Appendix 2-1

Scoping Responses

Re: Timahoe North Solar Project Scoping (County Kildare)

Map 2

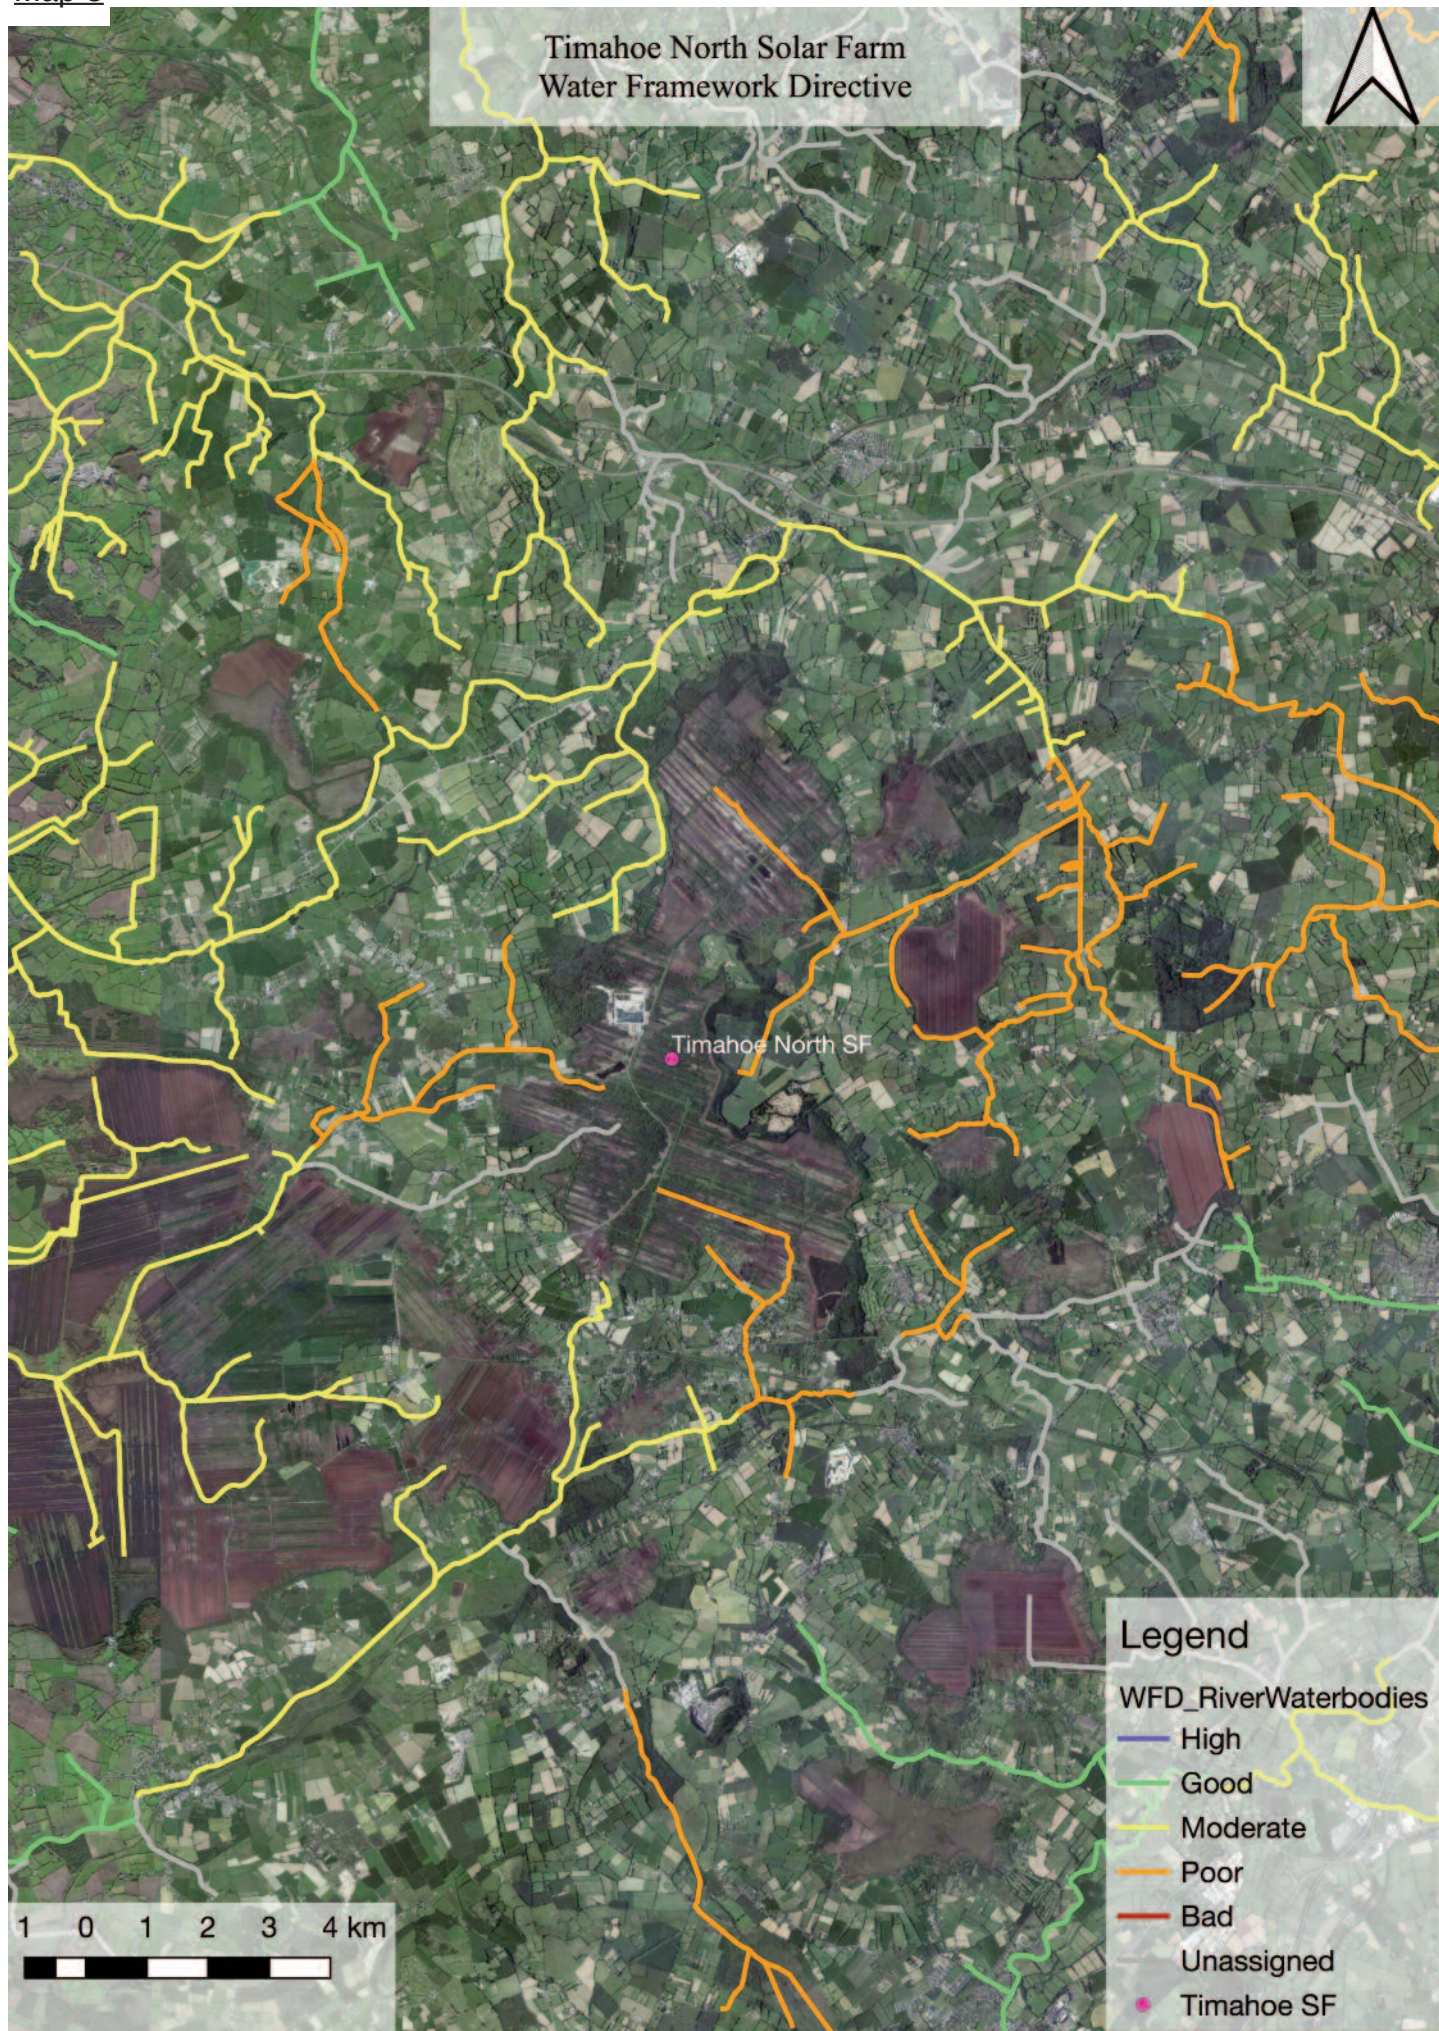
Curlew (Map 2)

The Curlew is one of the most endangered species in Ireland and the breeding population has declined by 78% over the past 40 years with less than 130 breeding pairs left (Birdwatch Ireland I-WeBS Newsletter August 2017). The IPCC would like to remind you that this bird is listed as an ANNEX II section II bird species within the E.U. Birds Directive [Council Directive 79/409/EEC]

and also has a national status of Red on the Birds of Conservation Concern in Ireland list. The National Curlew Task Force is working to bring this species back from near extinction in Ireland and we would urge developers to liaise with them. The conservation of this species is of utmost concern. There is currently a national initiative to protect this species and the proposed project should take proper measures to ensure that this project is not detrimental to any efforts in restoring important breeding habitat. Map 2 shows the locations of previous curlew sightings (data from National Biodiversity Data Center) and these should be investigated to ensure that Curlew will not be adversely affected by either the construction works or through the operation lifespan of the solar farm. Please ensure that a full bird survey is undertaken on this site.

Map 5

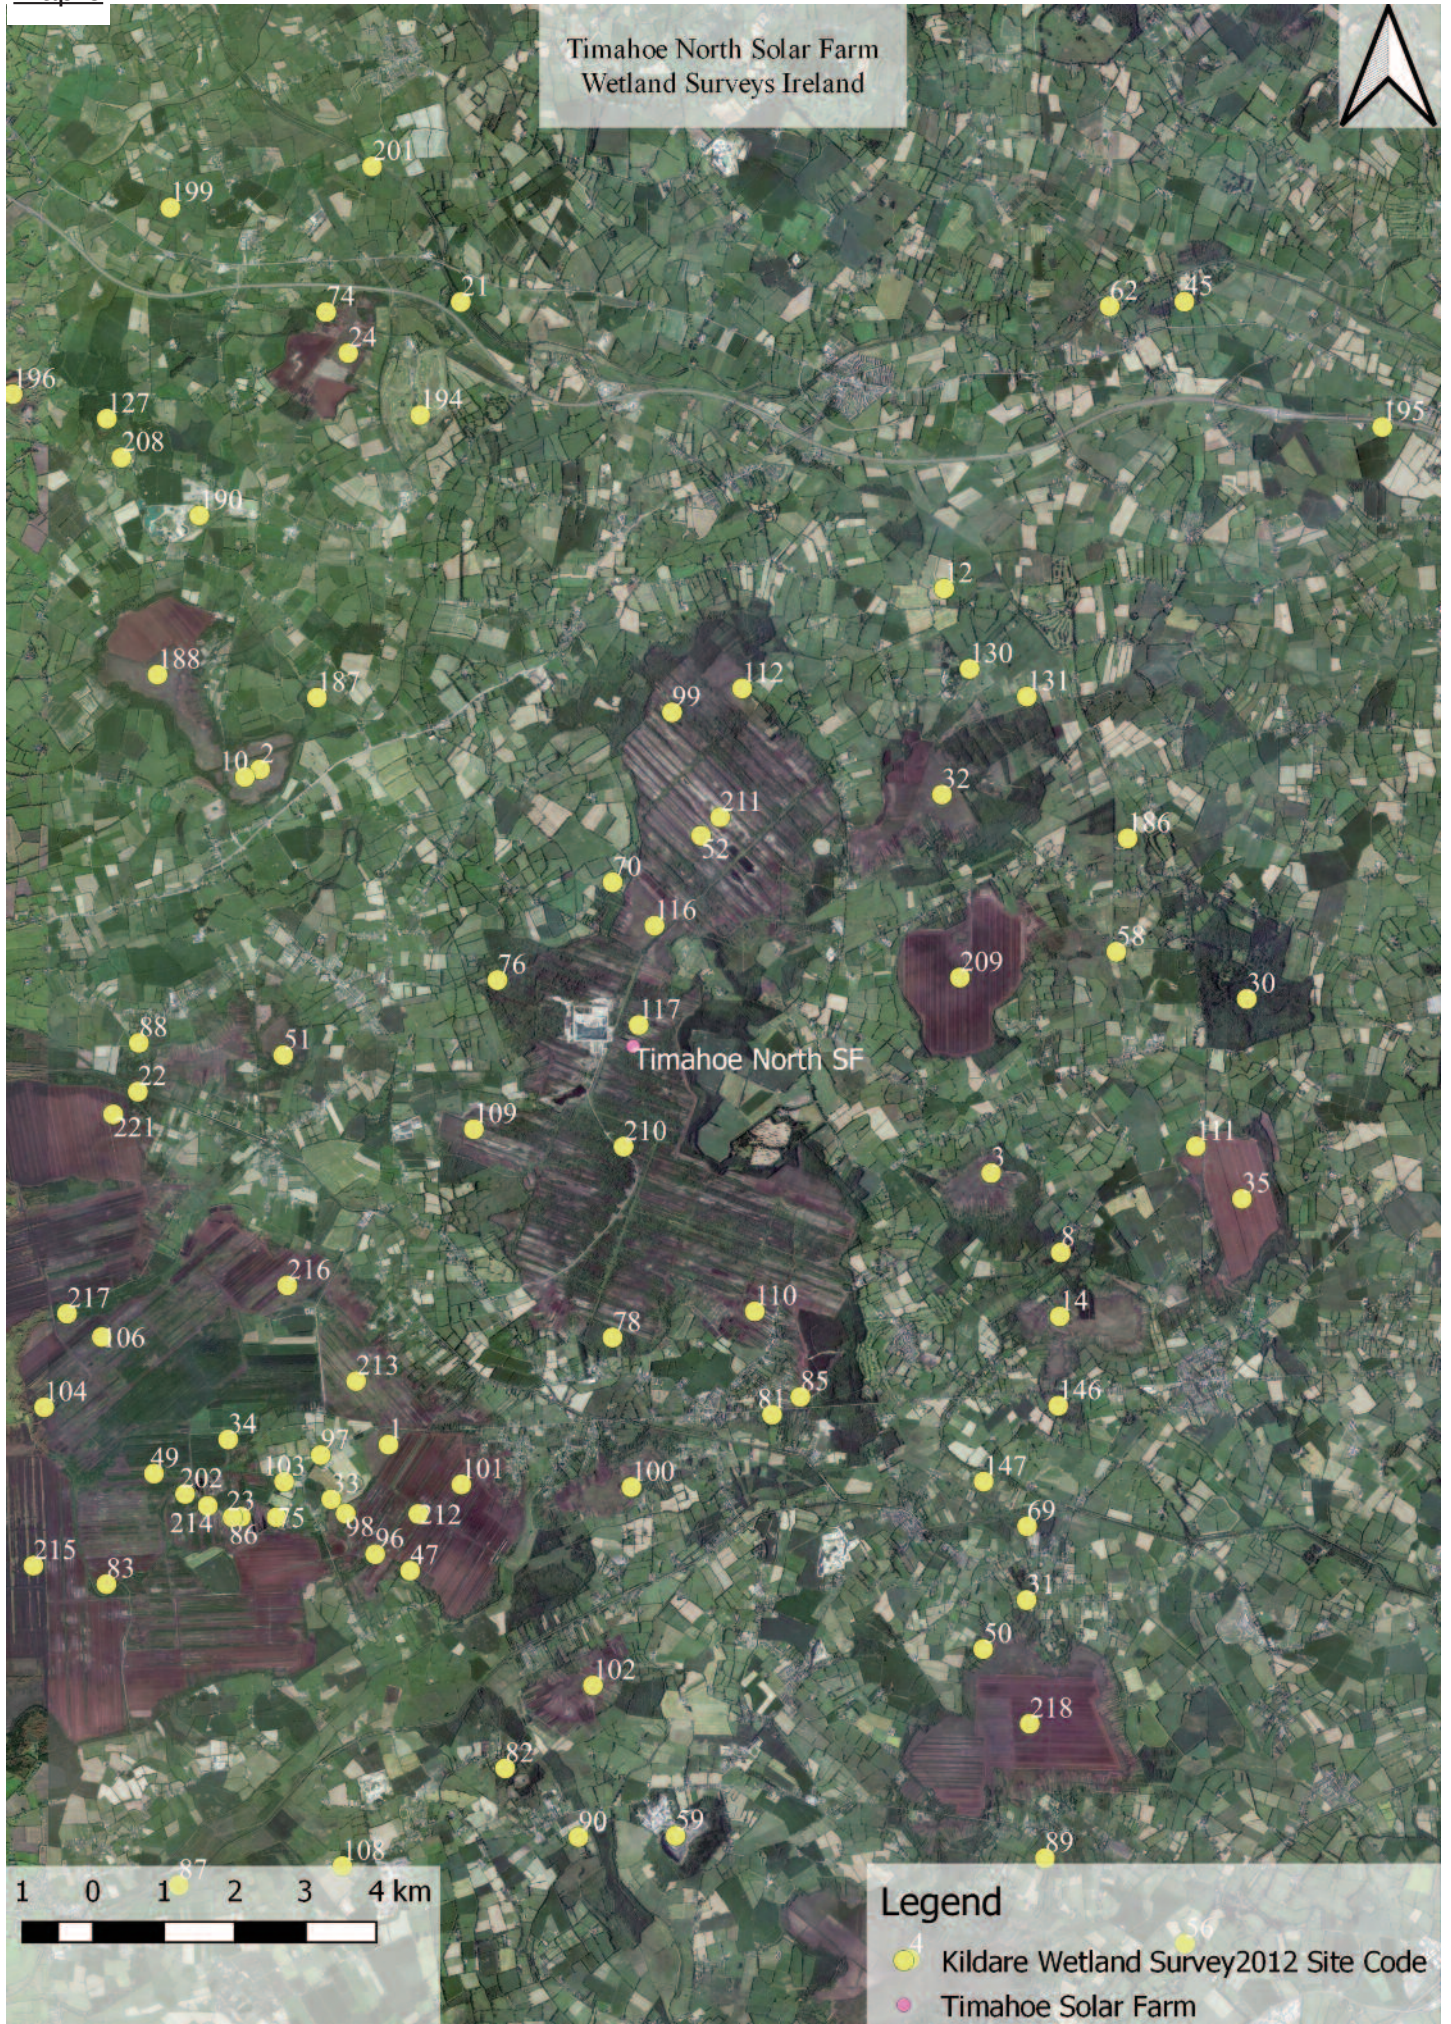
National Monuments (Map 5)

As can be seen on Map 5, there are a number of recorded archeological sites on the perimeter and within Timahoe Bog and surrounding area. These form a context for the peatland site. Proper measures should be taken to protect and preserve these national monuments. They may be damaged from a change in hydrological functioning or from being exposed after construction works. Proper plans would account for these historical sites and contain contingency plans in the event of uncovering new finds and also methods of construction and operation that would erase any chance of damage to the ones already known. We would also implore the developers to conduct a thorough investigation ensuring a complete inventory of archeological evidence is conducted including geophysical examinations of the area.
